## TECHNICAL MEMORANDUM

To: Aaron Zimmerman DDOT

From: Katie Wagner, PE, PTOE  
Erwin Andres

Subject: Reunion Square Building 4 – Response to DDOT Comments

Figure 2: Detailed Curbside Management Plan

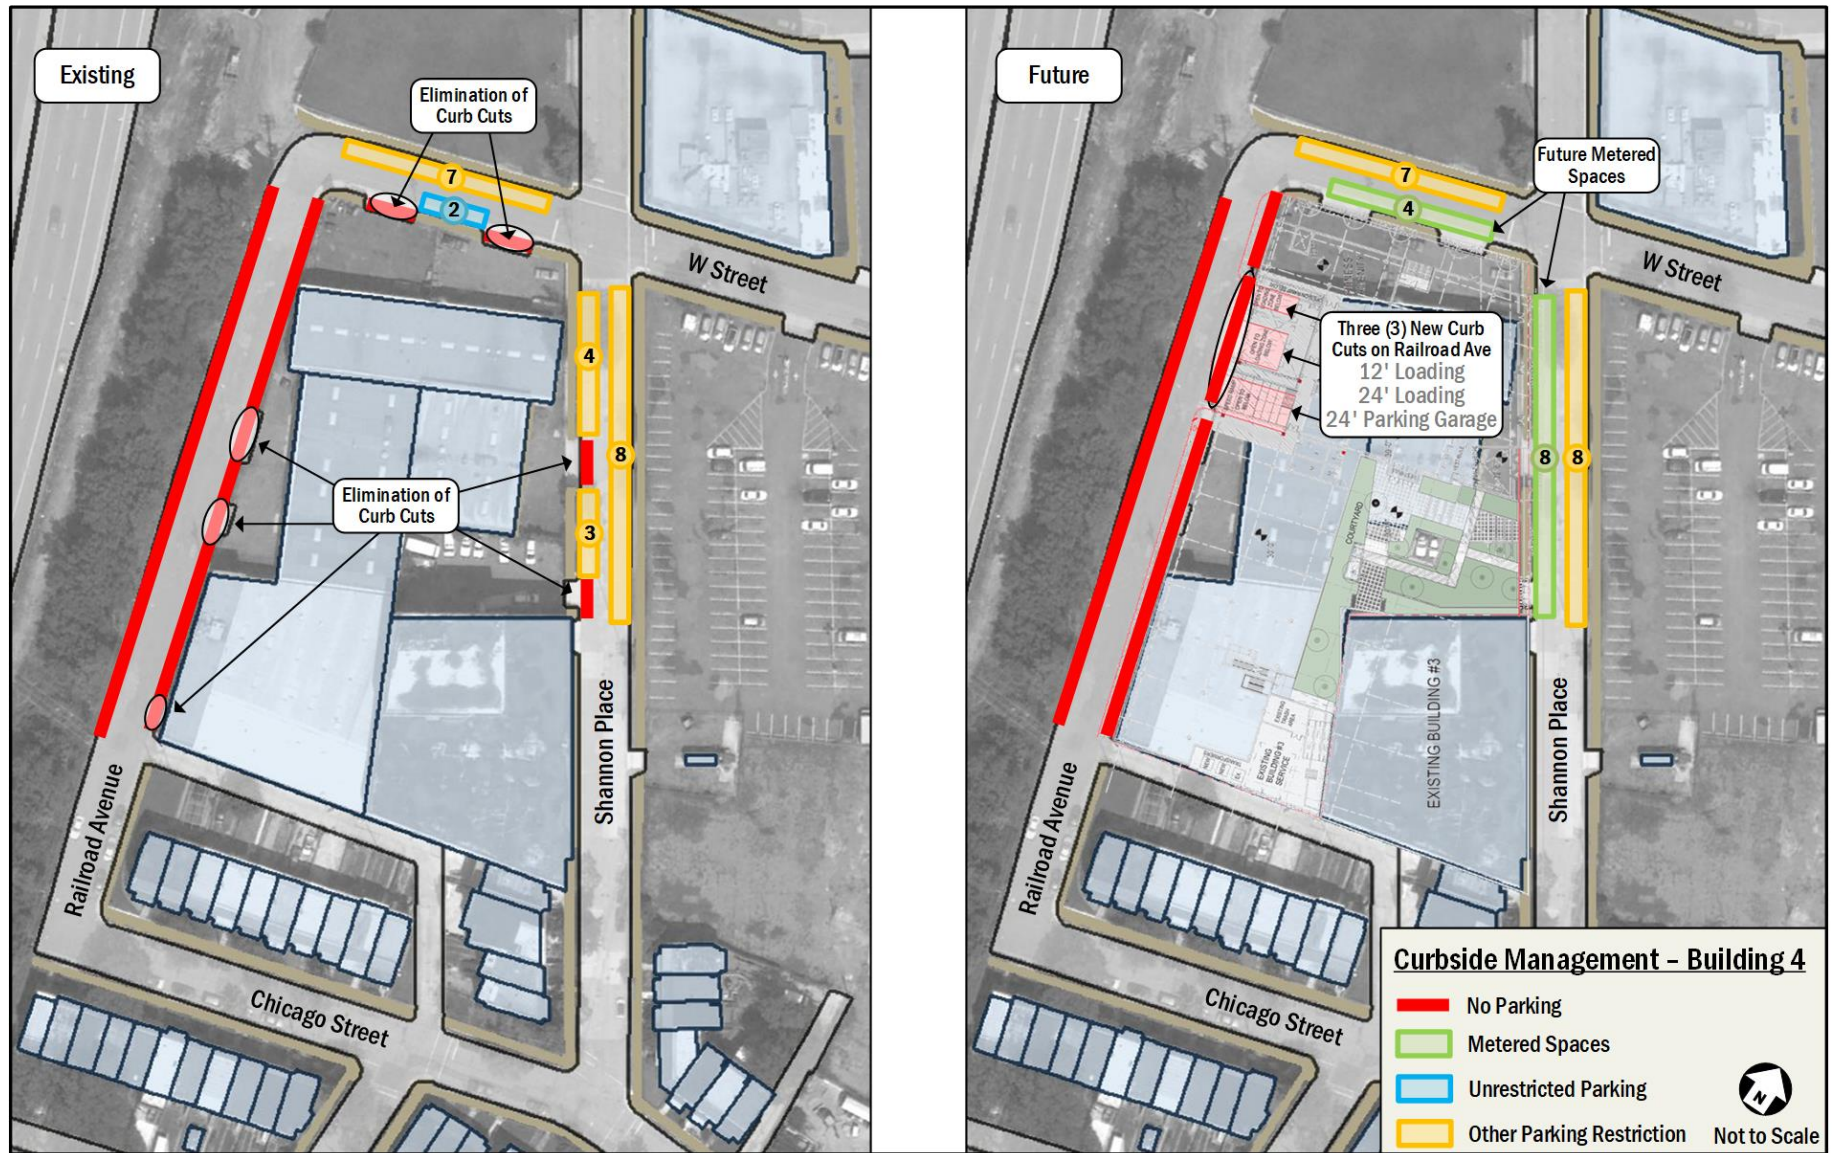
8. *Provide a detailed curbside management and signage plan, assumed to include multi-space meter installation at the Applicant's expense, consistent with current DDOT policies;*

**Response: The applicant agrees to continue coordination; the preliminary curbside management plan is provided with this memo.**

TITLE:  
STREET  
SECTIONS:  
RAILROAD AVE

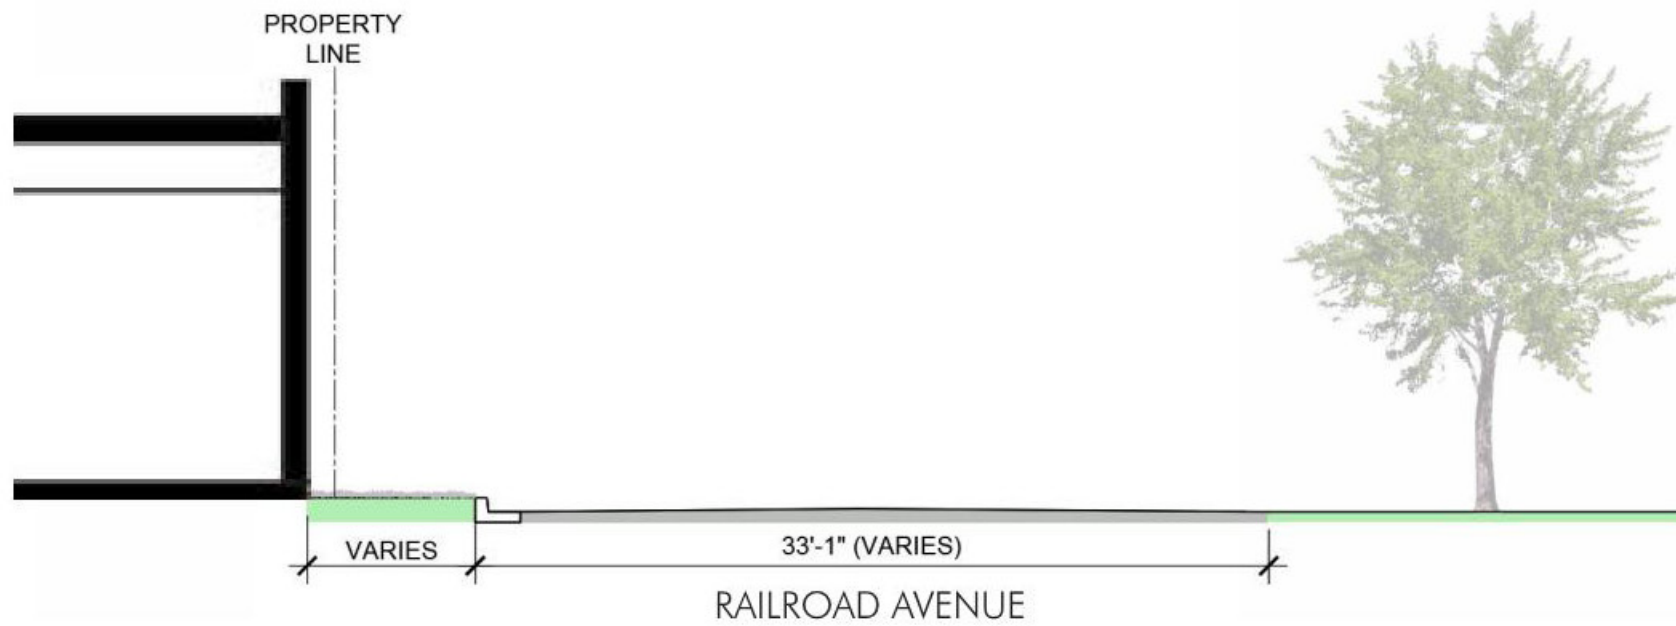
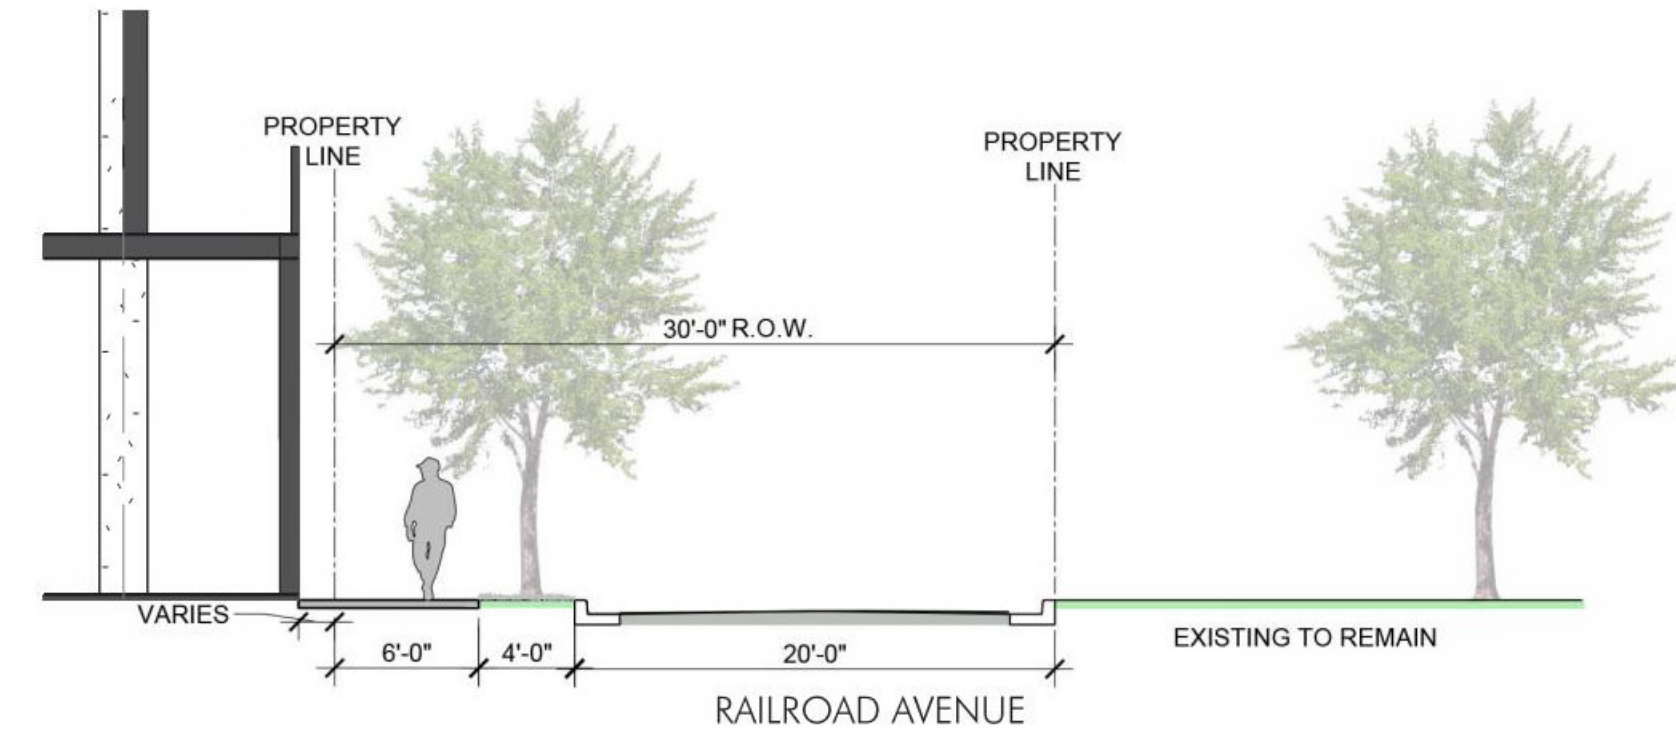
- 2. Upgrade Railroad Avenue SE between Chicago Street and W Street to include a curb on the west side and a row of street trees. Work with DDOT to determine the ultimate cross-section of Railroad Avenue and which side of the street the row of trees will be installed;*

- *Install curbs on the west side of Railroad Avenue;*

- *Install one row of street trees along Railroad Avenue between Chicago Street and W Street on either the east or west side. If on the east side, then the curb must be moved at least 4 feet to fit tree boxes;*

**Response: The applicant agrees to this condition. Please see updated site plan included with this memo.**

**Response: The applicant agrees to continue coordination, please see updated site plan included with this memo.**

**Response: The applicant agrees to continue coordination, please see updated site plan included with this memo.**
